Permit Fact Sheet

Permit Number:	WI-0065919-02-0
Permittee Name:	Ron Ziegler Farm
Address:	N368 Hwy 51
City/State/Zip:	DeForest WI 53532
Discharge Location:	N368 Hwy 51, Deforest WI, 53532; Columbia County WI, Town of Leeds, W ½ of NW ¼ Sec. 33 T10N R10E
Receiving Water:	Unnamed tributaries within the Headwaters Yahara River Watershed, and ground waters of the state.
Stream Classification:	Yahara River 303d

CAFO Compliance Report (August 31, 2020)

Subject: Noncompliant Evaluation Review for the Animal Lots at Ron Ziegler Farm, Sec 33, T10N, R10E, Leeds Township, Columbia County – PLANS AND SPECIFICATIONS ARE REQUIRED

Picture 574 Waterway around farm, facing south-southwest.

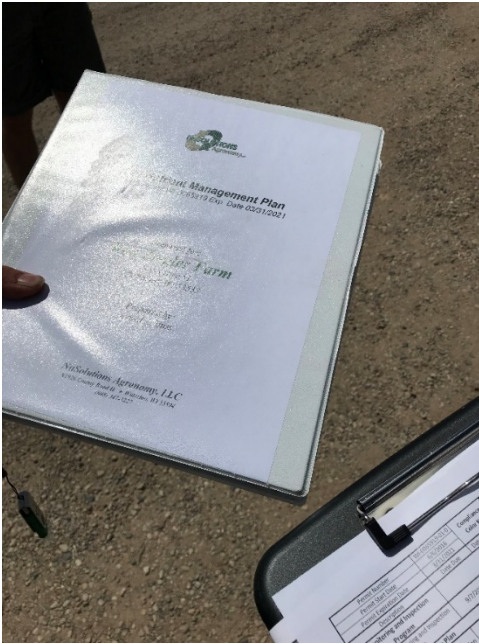
Ron Ziegler farm has a large waterway that encircles the farm production area. This waterway leads to a tributary of the Yahara River. The culverts and driveways were clear of waste feed or manure, except the area surrounding the feed storage area runoff collection that had been over topped. Rain gutters were not observed on most buildings. One area adjoining the waterway had washed out for a second time this year and the farm plans to regrade and reseed the area as soon as conditions allow. The farm also no longer composts anything onsite.
